# DEVIATION REQUEST AND DECISION FORM

Project Name : Struthers Ranch  
 Schedule No.(s) : 7136303010 and 7136303011  
 Legal Description : Lots 1 and 2 STRUTHERS RANCH SUB FIL NO 4

2.3.6.G Intersection Sight Distance  
Table 2-21

Exhibit 2  
*Intersection Sight Distance*  
*(Struthers Ranch Rd to the North)*

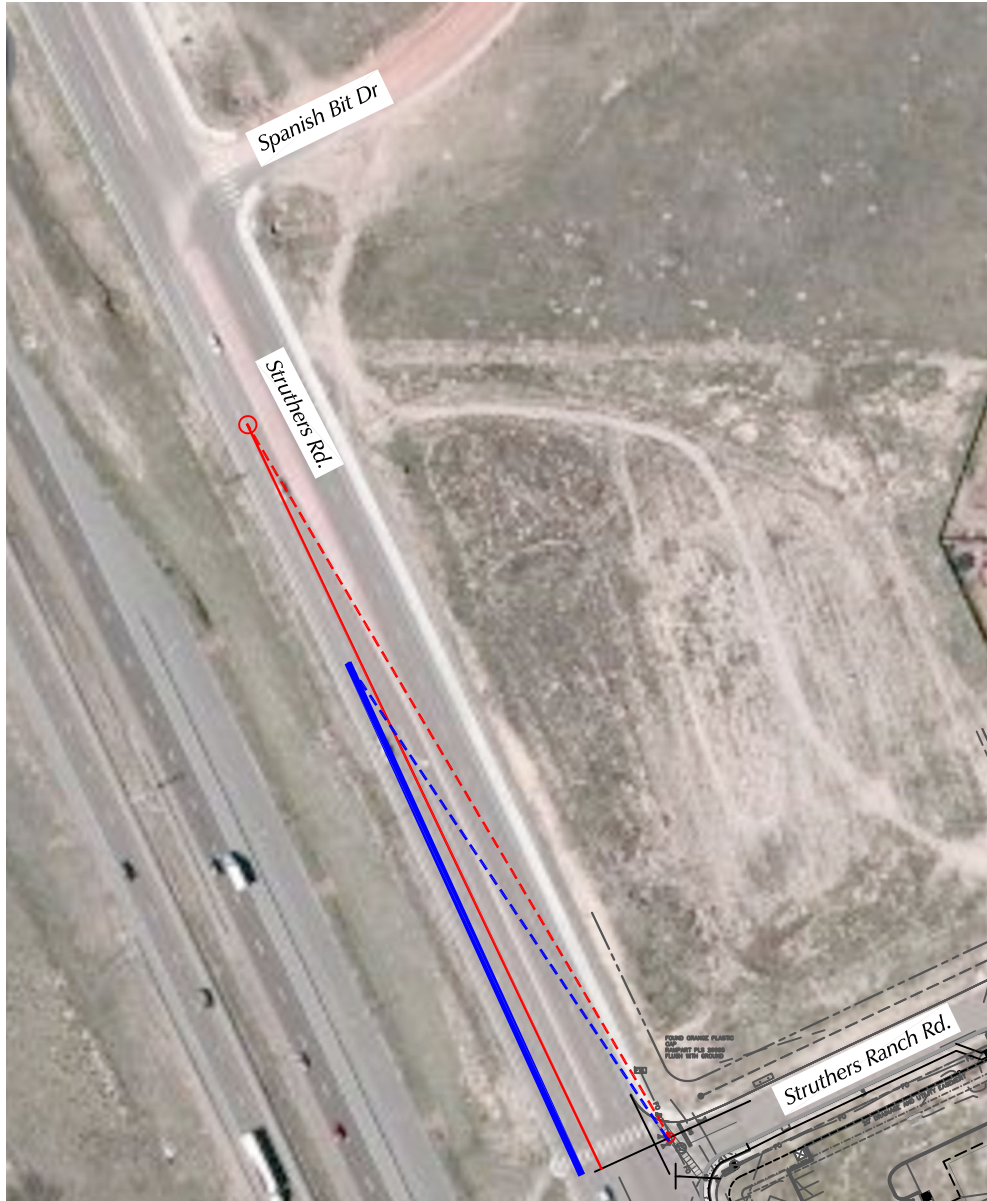
- The crest vertical curve on Struthers Road just north of Struthers Ranch Road limits intersection line of sight needed for intersection sight distance to the north for passenger vehicles making a left turn from westbound Struthers Ranch Road to southbound Struthers Road.
- The roadway design speed is assumed to be 50 mph (based on the southbound posted speed limit of 45 mph). Please refer to Exhibit 1 showing the subject location.
- Please refer to the TIS report dated February 21, 2023 for additional details.

- The sight distance to the north is shown in Exhibit 2. The field-measured sight distance to the north at this intersection is 450 feet. Given that the field-measured sight distance is less than the calculated sight distance of 640 feet, LSC recommends posting an "intersection ahead" warning sign (MUTCD W2-2) on the southbound approach to this intersection

- LSC recommends posting an “intersection ahead” warning sign (MUTCD W2-2) on the southbound approach to this intersection.
- Also, consideration could be given to modifying the posted speed limit zones on Struthers Road near this intersection to shift the 40-mph zone north such that a 40-mph speed limit sign is posted for southbound traffic between Spanish Bit and Struthers Ranch Road.
